RE: Docket No. CP13-483-000
Docket No. CP13-492-000

We are writing to express our support for the Commission's approval of the Jordan Cove liquefied natural gas export terminal and the Pacific Connector Gas Pipeline. The staff of FERC and the other reviewing state and federal agencies have studied and evaluated this project in great detail over the past ten years. The FERC has previously approved this project as an import facility. It is time to accept staff's findings as stated in the draft environmental impact statement that this project can be built safely with minimal adverse impacts.

Figure 1. From Zhang (2012). NAVD88 is basically the level of Mean Higher High Water. The scale in meters translates as 10 m ~ 33 feet. North, West, etc are model estimates for water heights at three sides of the JCEP ship-loading basin.

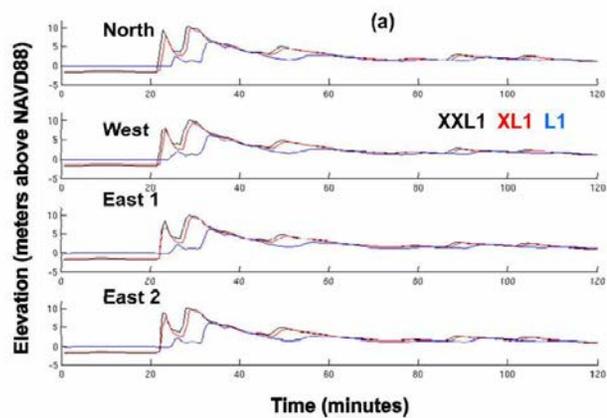
The Zhang model results are not explicitly shown in the DEIS. They are shown in attached Figure 1. The projected run-up amounts to about 10 m or +30 feet, which, apart from a +60 ft wall around the LNG storage tanks, is the tsunami from which the design engineers hope to protect the terminal and power plant. While this is a solid analysis so far as it goes, it does not go nearly far enough. Problems:

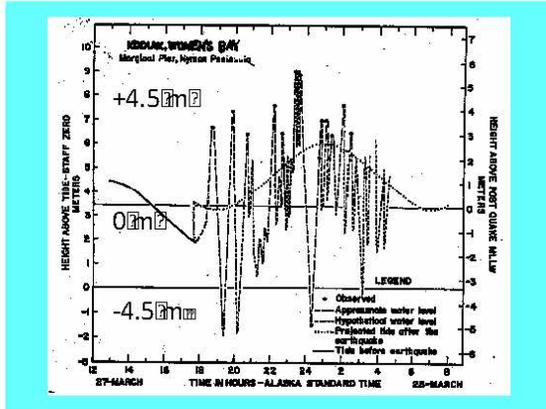
- (3) Real tsunami sequences are not just one wave (Figure 1). That is admitted in the DEIS, to the extent that likely intervals to second and third waves, characterized as decreasingly great, are given (pages 4-244 & 245), though not shown in the Zhang model. After both the 1964 Alaskan and 2011 Tohoku, Japan, subduction earthquakes, the series of waves actually continued from 10 to 20 hours, wave after wave, often with the greatest amplitudes many hours into the sequence.

Figure 4.7-1 Structures Within LNG Ship Transit Route Zones of Concern

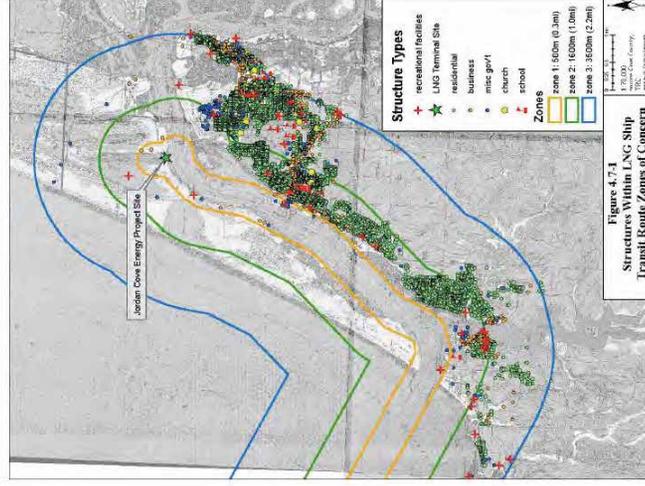
Zone 1 (yellow) - No one is expected to survive in this zone. Structures will self-ignite just from the heat.
Zone 2 (green) - People will be at risk of receiving 2nd degree burns in 30 seconds on exposed skin in this zone.
Zone 3 (blue) - People are still at risk of burns if they don't seek shelter but exposure time is longer than in Zone 2.
Map does not include the hazard zones for the South Dunes Power Plant and the Pacific Connector Gas Pipeline.
